# Access Compliance Report

## Public Rights-of-Way (Curb Ramps)

Intersection ID: 30513	Main Street: S_TRYON_ST	Cross Street: GENERAL_DR	Location: SW
ADA ID: EF1C9D7314E8	Ramp Type: PerpDiag	Initial Pass/Fail: Fail	Overall Compliance: No
		Severity Score: 12.5

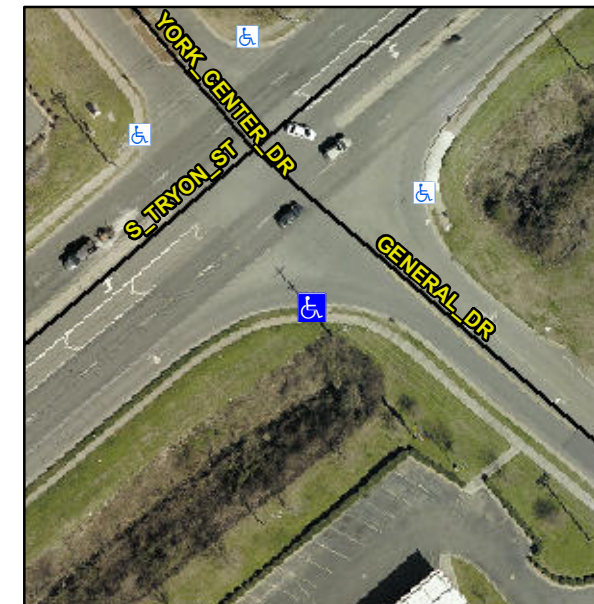
**R304.2.2**

Compliance	Description	Data	Compliance	Description	Data
N/A	Ramp Length (in)	90.0	No	Ramp Slope (%)	9.1
Yes	Ramp Width (in)	48.0	Yes	Ramp XSlope (%)	1.6
N/A	Flare Type LT	N/A	N/A	Flare Type RT	N/A
N/A	Flare Slope LT (%)	N/A	N/A	Flare Slope RT (%)	N/A
N/A	Flare Traversable LT?	N/A	N/A	Flare Traversable RT?	N/A
N/A	Landing Length (in)	N/A	N/A	DWS Provided?	N/A
N/A	Landing Width (in)	N/A	N/A	DWS Contrast?	N/A
N/A	Landing Slope (%)	N/A	N/A	DWS Length (in)	N/A
N/A	Landing X Slope (%)	N/A	N/A	DWS Full Width?	N/A
N/A	Landing Curb? (Y/N)	N/A	N/A	DWS Offset (in)	N/A
N/A	Shared Landing?	N/A			
N/A	Gutter Ponding?	N/A	N/A	Gutter Slope (%)	N/A
N/A	Gutter Lip Ht (in)	N/A	N/A	Gutter X Slope (%)	N/A
N/A	Painted X Walk1?	No	N/A	Painted X Walk2?	No
	X Walk 1 Direction	To NE		X Walk 2 Direction	To N
N/A	X Walk 1 Width (in)	N/A	N/A	X Walk 2 Width (in)	N/A
	X Walk 1 Slope (%)	3.0		X Walk 2 Slope (%)	1.5
	X Walk 1 X Slope (%)	0.1		X Walk 2 X Slope (%)	2.5

**Remove & Replace Curb Ramp With Two New Directional Ramps or Equivalent.**
